# Interurban Rail Trail at Red Barn Market

## A Saanich Centennial Trails Project: 2005–2006

#### Option 1:

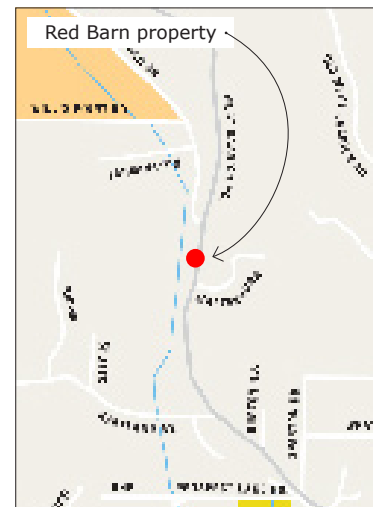
An option to route the trail behind the market should be explored with the Red Barn and/or property owners of the wetland west of the market. Use of a boardwalk could be considered for bikes and pedestrians along the wetland. Saanich has good examples of trail infrastructure successfully introduced into sensitive environments. This could also be a unique feature of the trail. Clear links to the market would be needed to provide access for trail users.
